REMARKS

Appln. No. 09/869,613
Amd. dated February 23, 2005
Reply to Office Action of August 23, 2004

Amendments to the Drawings

Attached to this paper are replacement drawings for Figs. 3-7 as well as annotated sheets showing changes to the original drawings.

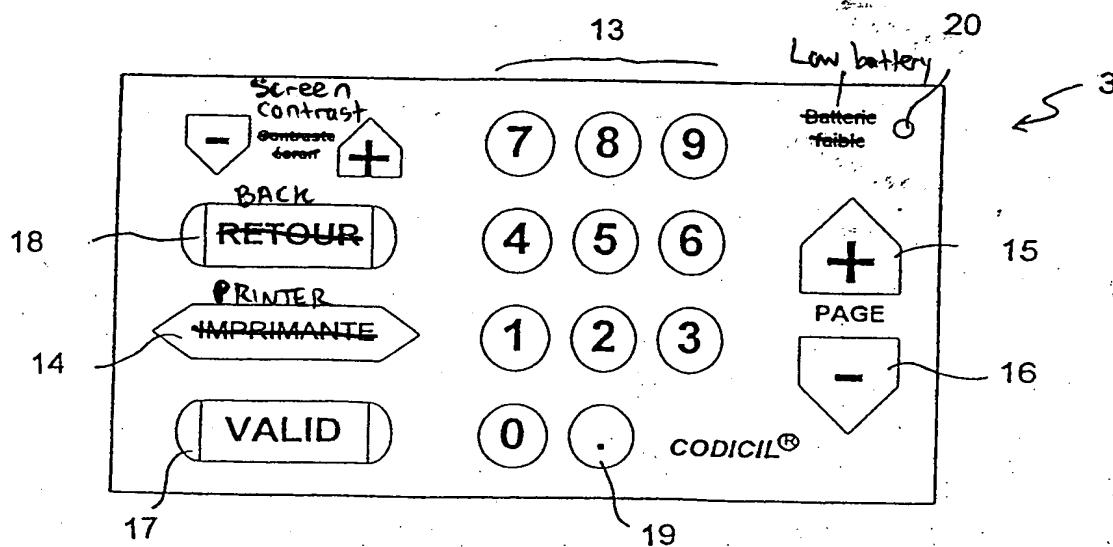
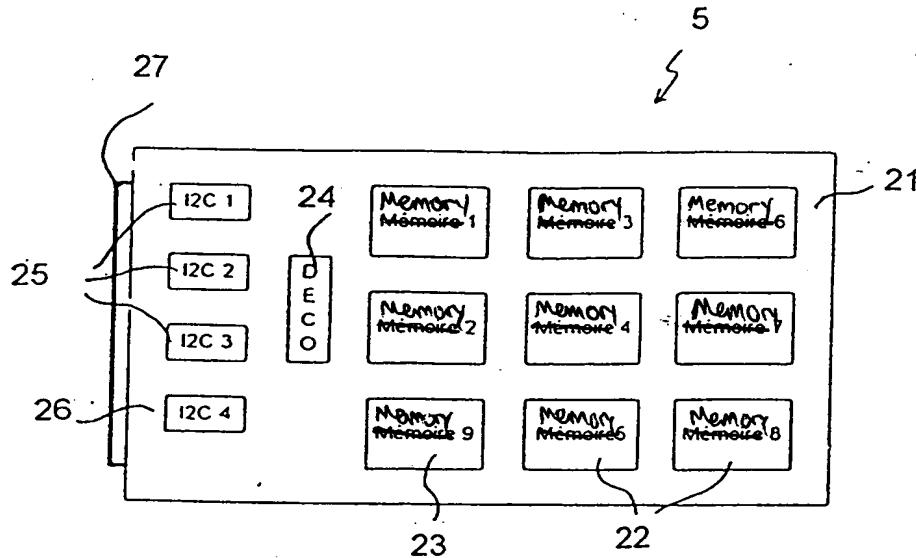
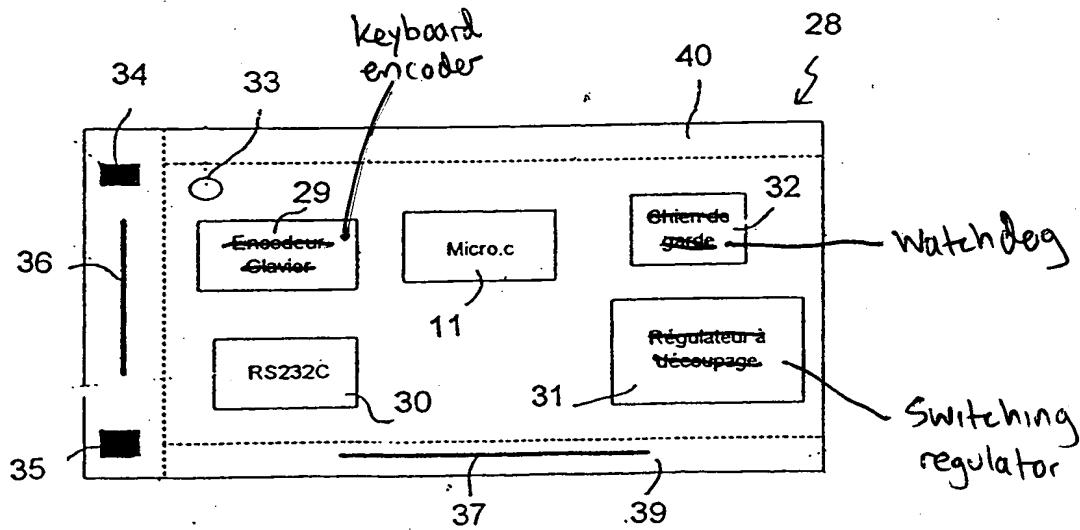
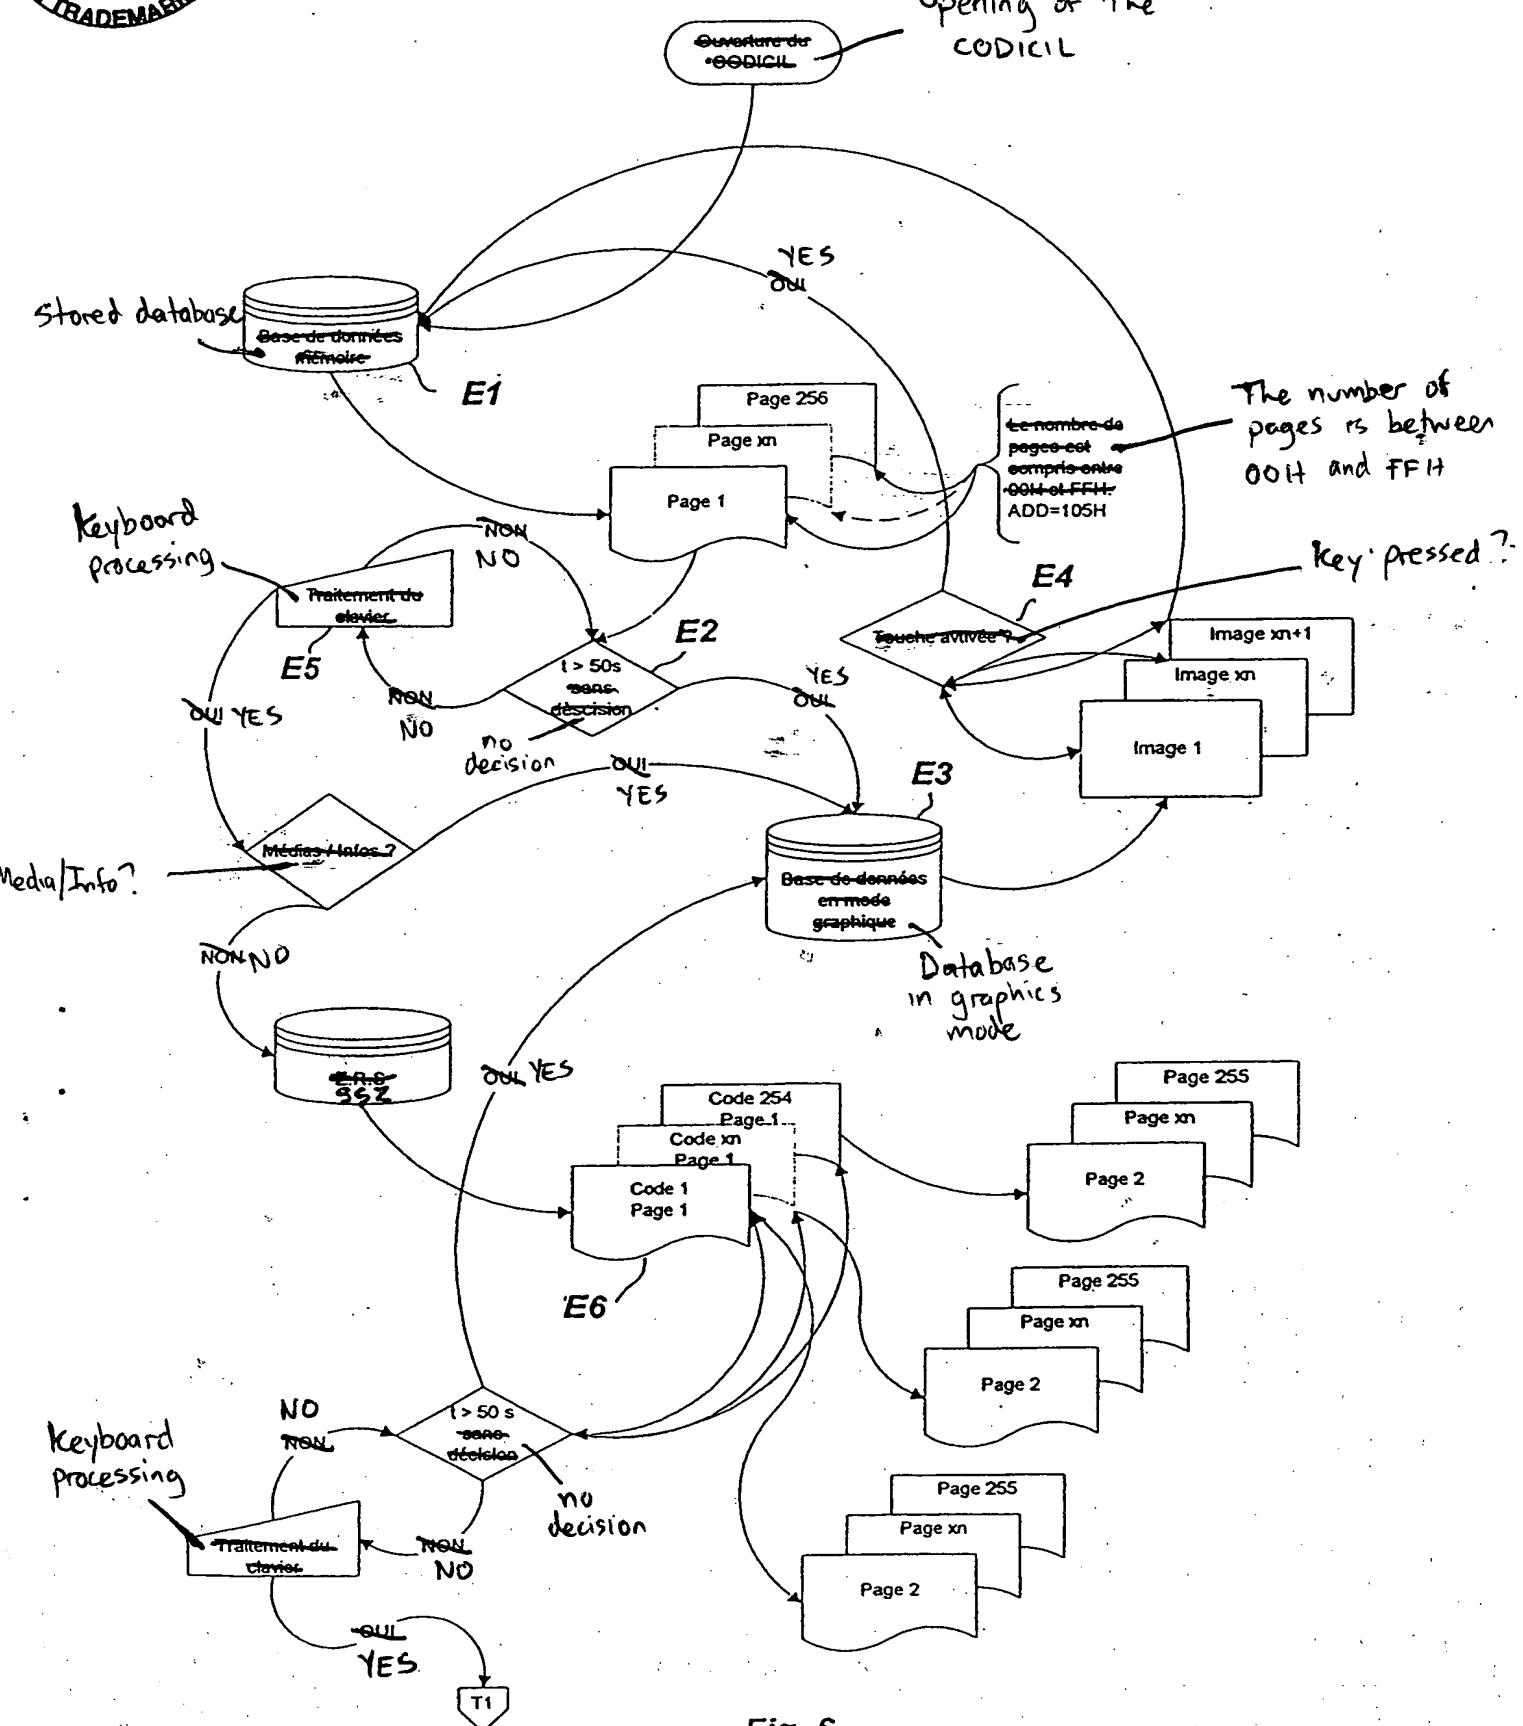
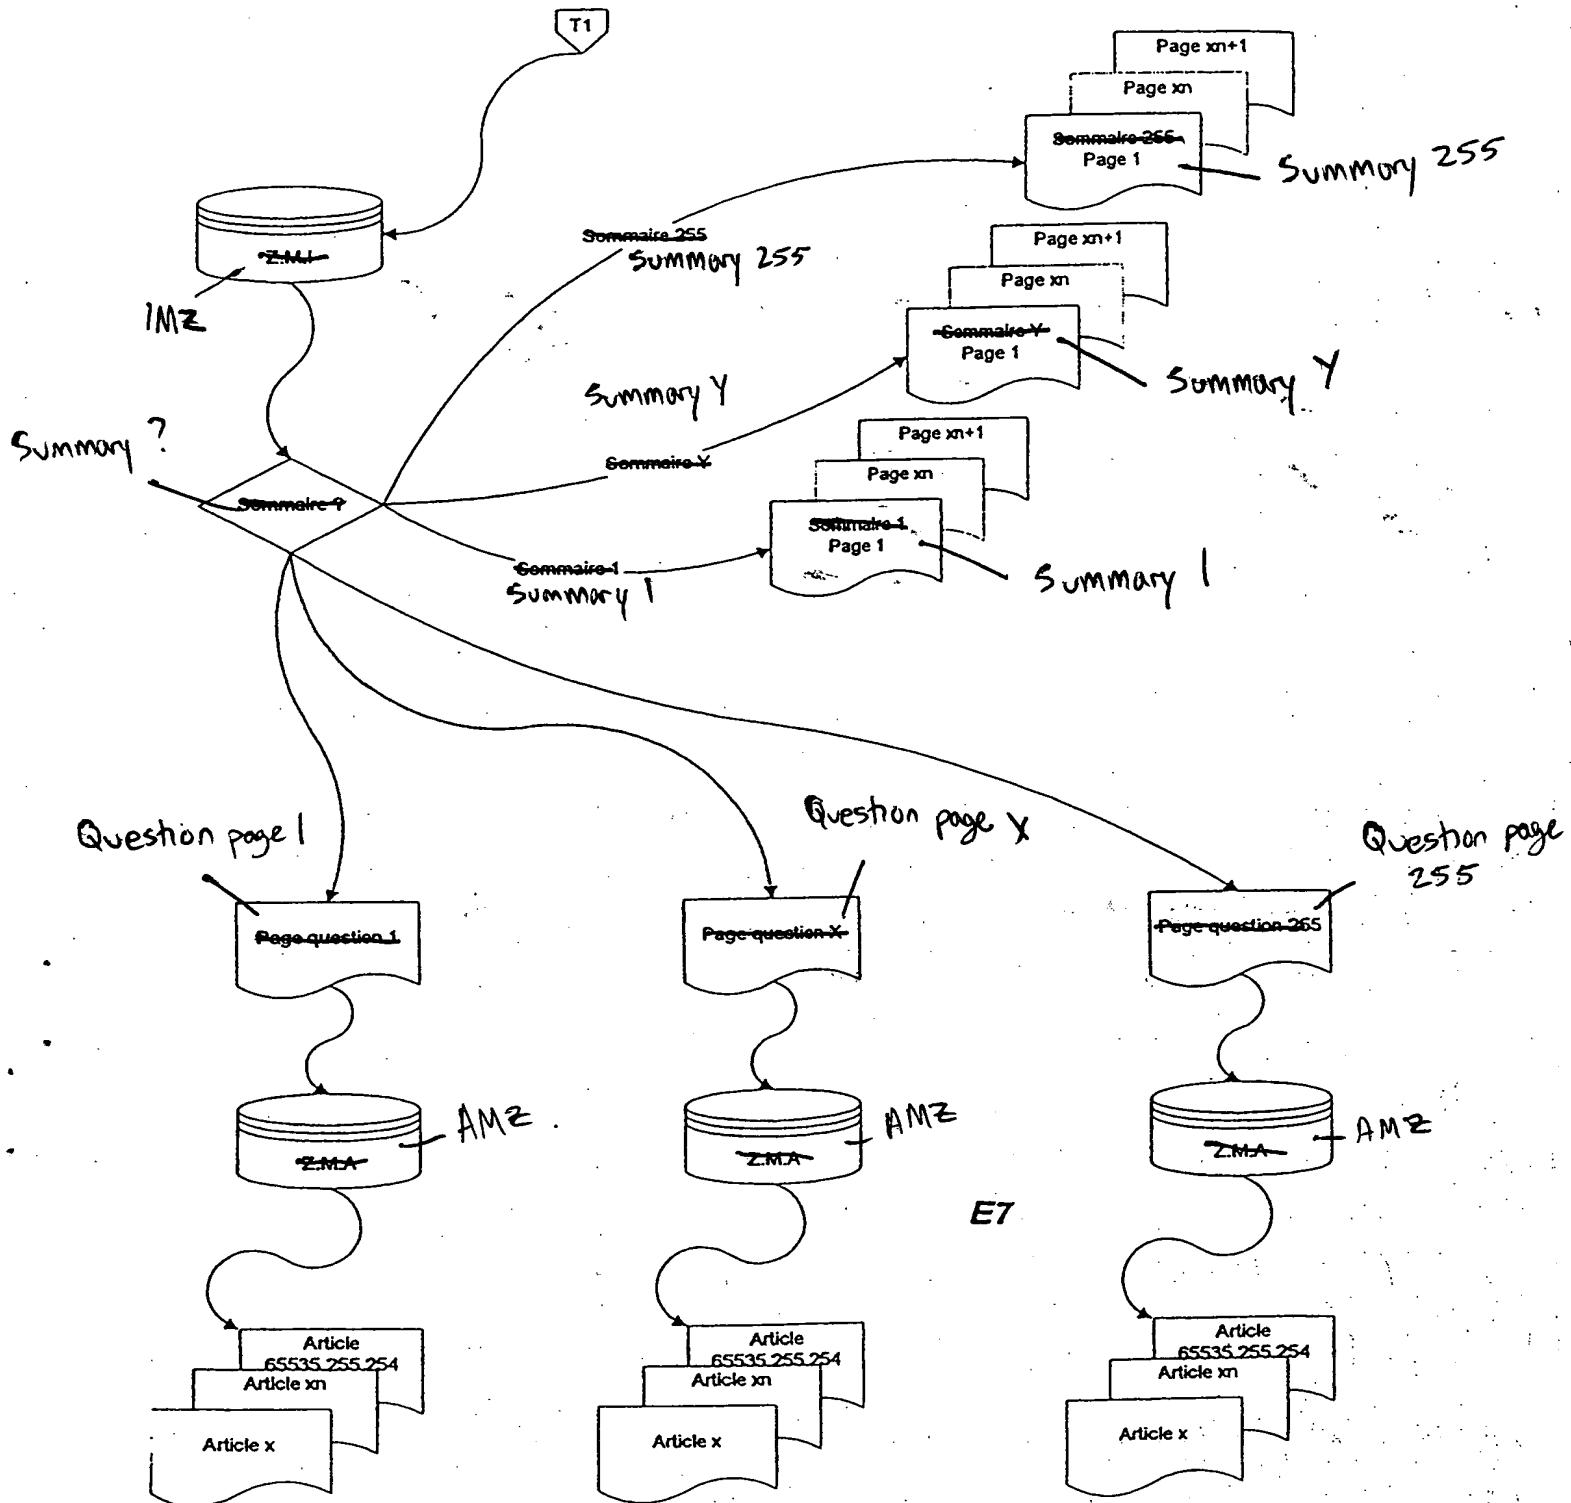
The drawings were objected to because the drawing elements were not labeled in English. Substitute drawings are attached herewith which provide the labels in English. Withdrawal of this objection is respectfully requested.
